Addendum No. 4

Diablo Road Trail and Drainage Improvement Project Project No. C-055

SHEET NUMBER
3
OF 22 SHEETS
PROJECT NO.
8870.000.011

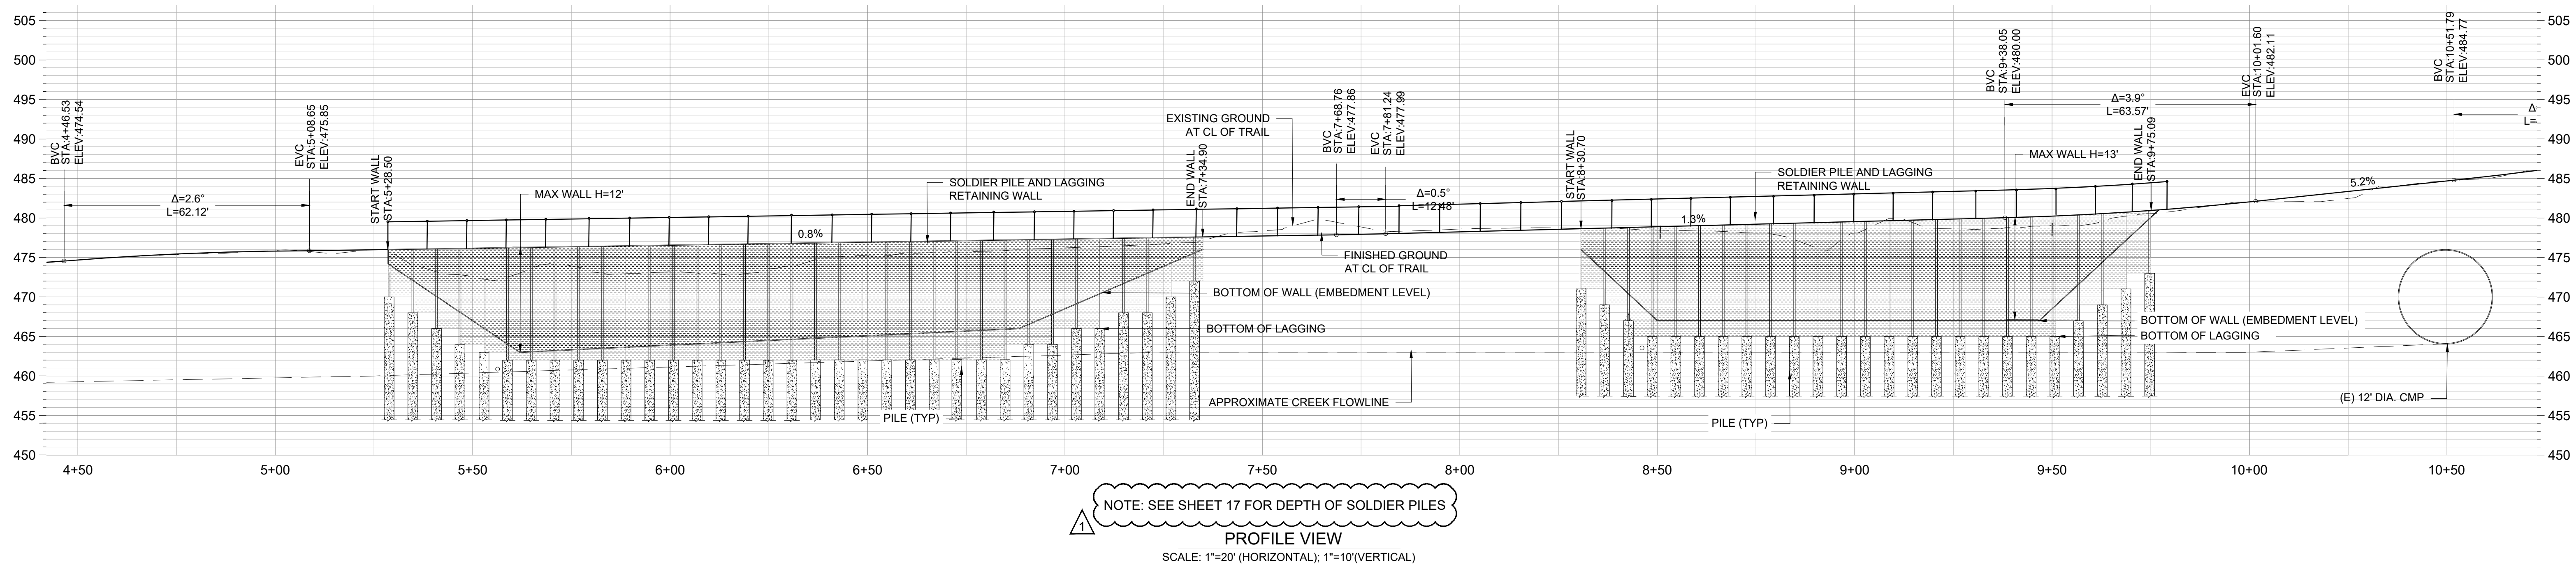
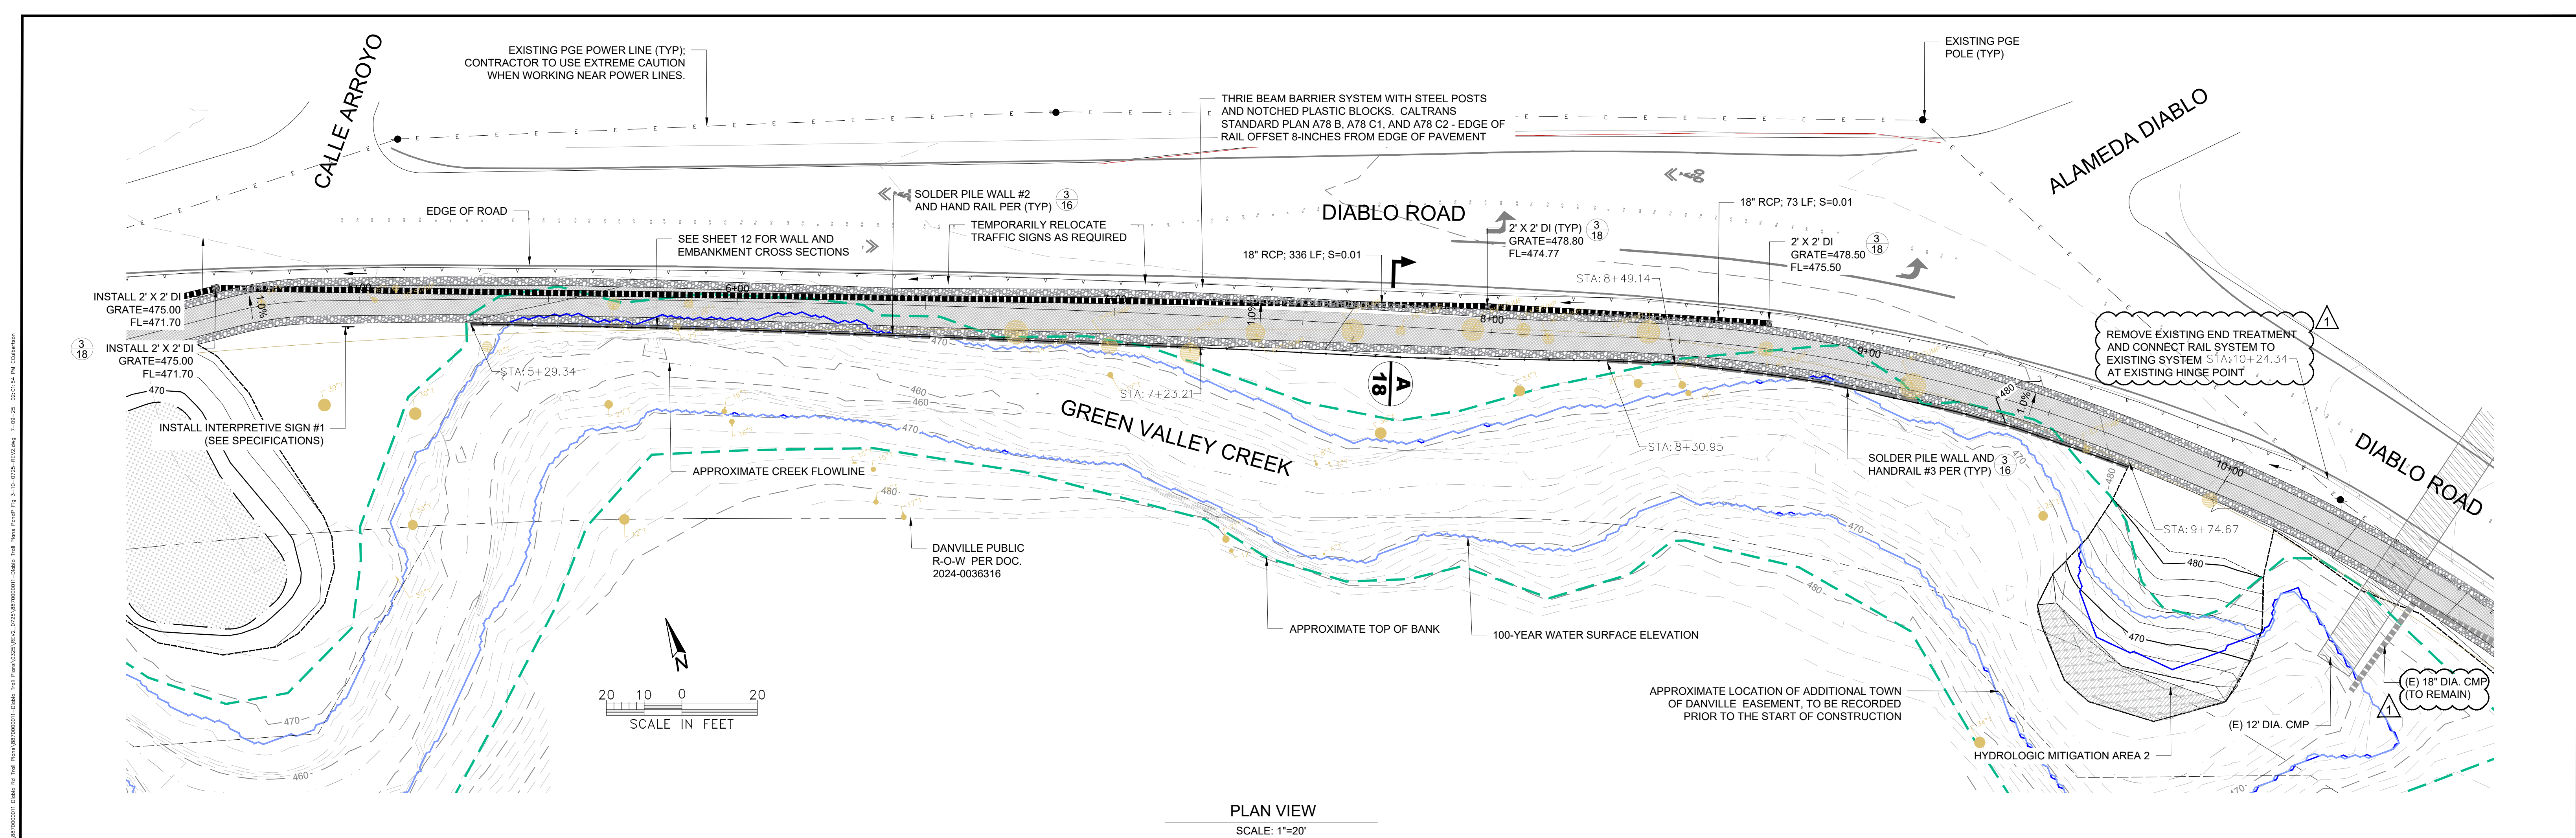
54- There are several rock check dams shown on plan sheet 3, how do they get paid.

76- Plan Sheet 3 shows 3 each 2'x2' rock check dams to be installed. There is no bid item for this work, nor does the measurement and payment for Bid Item 21 address these check dams. Please confirm these check dams are to be measured and paid for under Bid Item 21, or please provide a bid item for this work to be performed under.

- a. Rock check dams are paid from bid item 21 as added in Addendum 2.
